Parks Canada RNUP Office, Markham ON		Stantec Ottawa Office
File:	RNUP 2018 Tender Septic System Replacements	Date:	August 3, 2018

Following the optional site tour with tenderers on July 31st, 2018, Addendum no 1 to be issued.

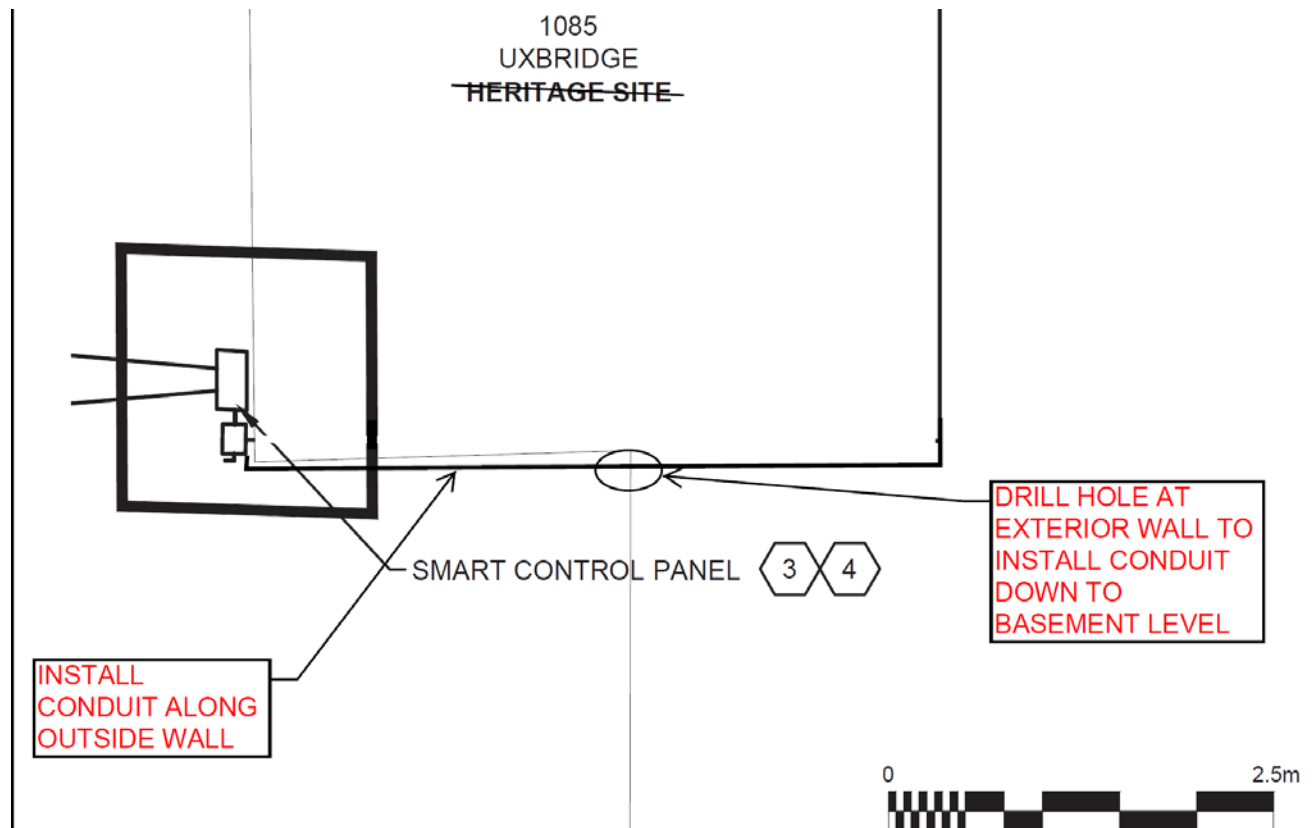
- Drawing E-01a: 1085 Uxbridge-Pickering: Detail 2: the mention "HERITAGE SITE" shall be deleted. Tenderers are advised that power wiring conduit shall be installed along the south wall before to be inserted at west side exterior wall, to access basement level, as shown on following page.
- Tenderers are reminded that the following residences have Municipal Heritage Status, so they shall bore the cost of scan at exterior wall and any other pertinent location where the power wiring and conduits are to be installed:
 - o 4440 Sideline 34
 - o 6445 19th Avenue
 - o 10888 Reesor Road
 - o 7528 Elgin Mills Road
 - o 7558 Elgin Mills Road
